## Proposal for an amendment to ECE/TRANS/WP.29/2022/7

The changes compared to documents ECE/TRANS/WP.29/2022/7 are marked in **red font**.

*Figure, amend to read:*

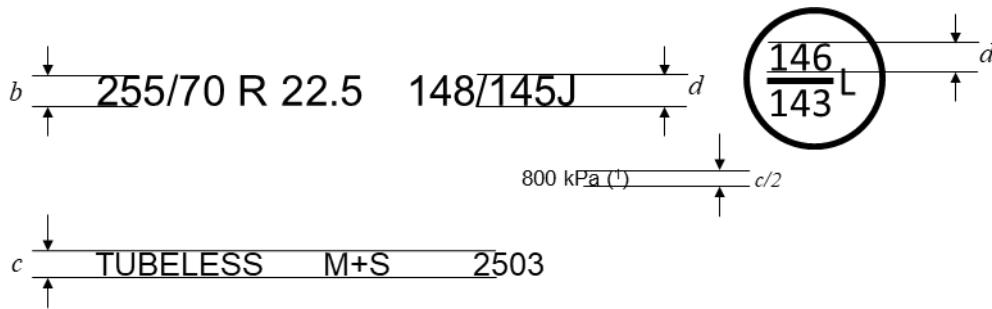
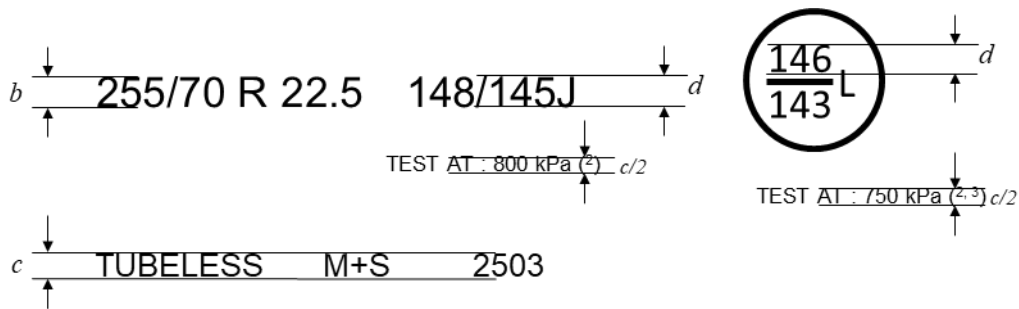
*Annex 3,*

**"Example 1:**

- (1) PSI marking instead of kPa is allowed for tyres first type approved before 1 January 2018. The kPa marking may be preceded by "TEST AT : " or, alternatively, by "TEST INFL : " or the symbol "@".

**Example 2:**

- (2) "TEST AT : " may be replaced by "TEST INFL : " or the symbol "@ " or be omitted.  
 (3) The indication of a second inflation pressure for the additional service description is optional. If there is no indication, the same test inflation applies to both load/speed combinations.
